CITY OF SACRAMENTO PLANNING COMMISSION
 1231 "I" STREET, SUITE 200, SACRAMENTO, CA 95814

APPLICANT <u>Abdy Taberi, 9718 Fair Oaks Boulevard #E, Fair Oaks, California 95628</u>
OWNER <u>Abdy Taberi, 9718 Fair Oaks Boulevard #E, Fair Oaks, California 95628</u>
PLANS BY <u>West Home Construction, 9718 Fair Oaks Boulevard #E, Fair Oaks, California 95628</u>
FILING DATE <u>February 25, 1992</u> ENVIR. DET. <u>Exempt (15303a, 15305a)</u> REPORT BY <u>Cindy Gnos</u>
ASSESSOR'S PCL. NO. <u>027-0341-012</u>

- APPLICATION:**
- A. Variance to reduce the west side setback from five feet to three feet four inches in order to construct a 1,205 square foot single family residence on 0.07± vacant acres in the Standard Single Family (R-1) zone.
 - B. Variance to reduce the east side setback from five feet to one foot eight inches.

APPLC.NO. P92-046

EXHIBIT - A
SITE PLAN

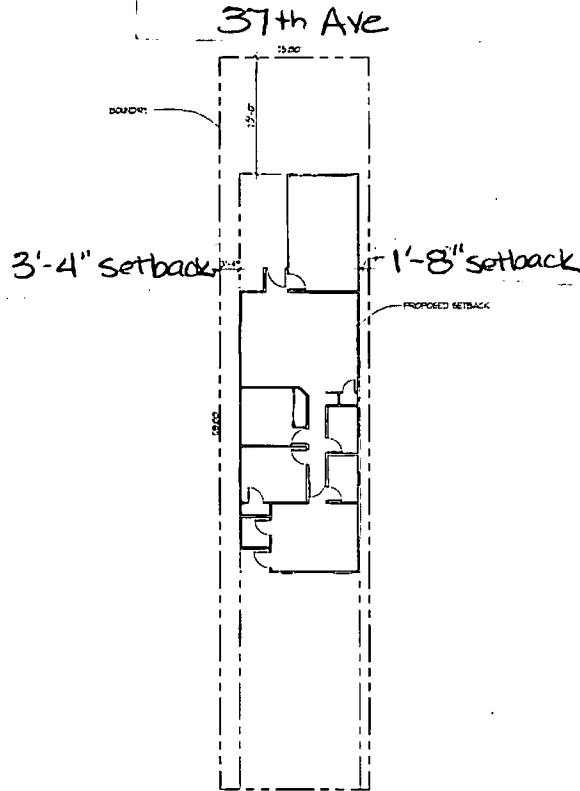
Recommend denial for the request for the west side variance. The plans should be revised to create a zero-lot-line on the east side of the parcel. This would allow the adjacent 25 foot wide parcel and this parcel to share the same common fire wall on the property line in the center and better utilize property and leave more distance between the structures adjoining these two parcels. The structure to the west has a fire place on the east side. This is not a safe condition with only six feet between the chimney and the roof line next door.

- 2. The applicant shall submit a revised site plan for review and approval of the Planning Director which shifts the entrance closer to the street.
- 3. The applicant shall submit revised elevations to the Planning Director for review and approval prior to the issuance of Building Permits. The revised elevations shall include:

Staff has reviewed the recommendation of the South Sacramento Community Planning Advisory Council. If the parcel were to have no setback on the east side, a maintenance easement would be required and may be impossible to obtain. This would also dictate that the adjacent property be developed as a zero-lot-line. Staff recommends the setbacks be provided as indicated on the submitted plans.

EXHIBIT - B
ELEVATIONS

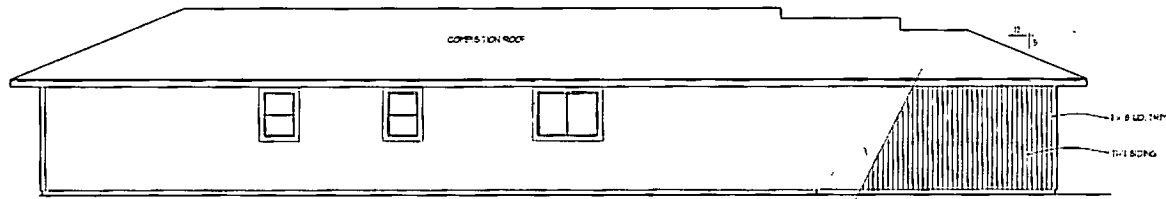
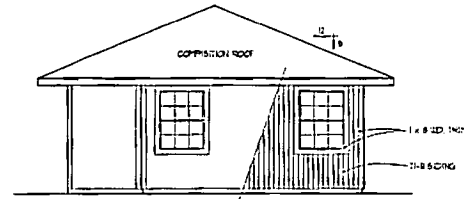
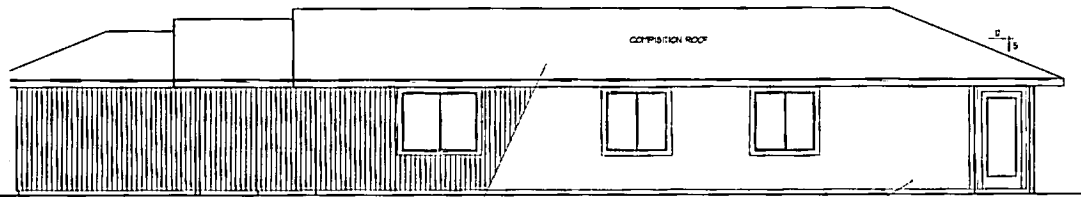
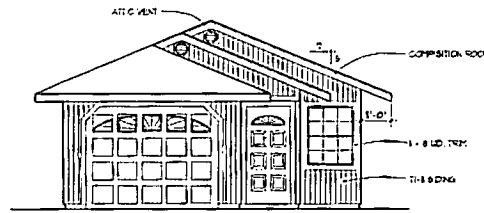
The building has been designed with a single car garage. The applicant has designed the structure this way to minimize the amount of garage visible at the street. The applicant has also designed the structure so the front door, as well as a large window from the living room, faces 37th Avenue. The applicant should provide a raised panel metal garage door, a raised panel front door, and gridded window facing the front as indicated on the submitted plans. The applicant should however, shift the entrance closer to the street. This would reduce the dominance of the garage, as well as add more area to the living room. The applicant should also add a gridded window in the center on the west side of the garage. The applicant proposes T1-11 siding and composition shingle roof. Staff suggests the front elevation have horizontal lap siding. The lap siding should wrap a minimum of two feet on the east and west sides of the house. The roof material should also be a minimum of 25 year rated laminated dimensional composition shingles. Staff also suggests that the mechanical equipment not be roof mounted. It should either be in the attic or on the ground in the rear yard.

- a. add a gridded window in the center on the west side of the garage;
 - b. the front elevation and two feet along the east and west sides of the house shall have horizontal lap siding;

- c. the roof material shall be a minimum of 25 year rated laminated dimensional composition shingles; and
 - d. the applicant shall provide a raised panel metal garage door, a raised panel front door, and gridded window facing the front as indicated on the submitted plans.
